Access Compliance Report

Public Rights-of-Way

(Pedestrian Signals)

Intersection ID: N/A	Main Street:	Cross Street: N/A	Location: N/A
ADA ID: BD97E4C45E61	Signal Type: Two Push Buttons-APS	Overall Compliance: No	Severity Score: BTN 1:N/A BTN 2: N/A No BTN: N/A
Codes/Mitigation Info/Possible Solution		Field Measurements/Component Compliance

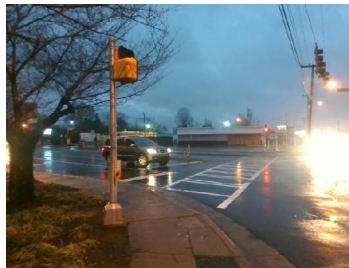
PROW/ADA: R404.2, R406.2,

Compliance	Description	Data	Compliance	Description	Data
	Button Count	Button2	N/A	Distant to Additional Button (in)	N/A
	Additional Button Present?	No		Additional Button ID	N/A
N/A	Signal Buttons Required?	N/A	N/A	Additional Ped Posts Required	N/A
	How Many Ped Street Xings?	2		Located In An Island/Median?	No
N/A	B 1 Sign Present?	Yes	N/A	B 2 Sign Present?	Yes
Yes	B 1 Sign Purpose?	Yes	Yes	B 2 Sign Purpose?	Yes
Yes	B 1 Sign Lettering & Contrast?	Yes	Yes	B 2 Sign Lettering & Contrast?	Yes
Yes	B 1 Parallel To XWalk?	Yes	Yes	B 2 Parallel To XWalk?	Yes
Yes	B 1 PAR to Button?	Yes	Yes	B 2 PAR to Button?	Yes
Yes	B 1 PAR to XWalk?	Yes	Yes	B 2 PAR to XWalk?	Yes
Yes	B 1 Clear Floor Space?	Yes	Yes	B 2 Clear Floor Space?	Yes
N/A	B 1 FWD Approach?	Yes	N/A	B 2 FWD Approach?	Yes
N/A	B 1 FWD Approach Constrained?	No	N/A	B 2 FWD Approach Constrained?	No
No	B 1 FWD Approach Reach (in)	7.0	No	B 2 FWD Approach Reach (in)	9.0

N/A	B 1 FWD Approach Width (in)	N/A	N/A	B 2 FWD Approach Width (in)	N/A
N/A	B 1 FWD Approach Obstruction?	Yes	N/A	B 2 FWD Approach Obstruction?	Yes
N/A	B 1 FWD Approach Obstruction Dist (in)	1.0	N/A	B 2 FWD Approach ObstructionDist (in)	1.0
N/A	B 1 PARA Approach?	Yes	N/A	B 2 PARA Approach?	Yes
N/A	B 1 PARA Approach Constrained?	No	N/A	B 2 PARA Approach Constrained?	No
Yes	B 1 PARA Approach Reach (in)	6.0	Yes	B 2 PARA Approach Reach (in)	7.0
N/A	B 1 PARA Approach Width (in)	N/A	N/A	B 2 PARA Approach Width (in)	N/A
N/A	B 1 PARA Approach Obstruction?	Yes	N/A	B 2 PARA Approach Obstruction?	Yes
N/A	B 1 PARA Approach Obstruction Dist (in)	1.0	N/A	B 2 PARA Approach ObstructionDist (in)	1.0
Yes	B 1 Clear Floor Space Slope (%)	1.6	Yes	B 2 Clear Floor Space Slope (%)	1.0
No	B 1 Clear Floor Space XSlope (%)	3.4	No	B 2 Clear Floor Space XSlope (%)	3.1
N/A	B 1 PAR Slope (%)	3.5	N/A	B 2 PAR Slope (%)	2.7
Yes	B 1 Height (in)	39.0	Yes	B 2 Height (in)	40.0

Possible Solutions: Remove & Replace
Replace APS Button With New APS Button.
Remove and Replace Clear Space.
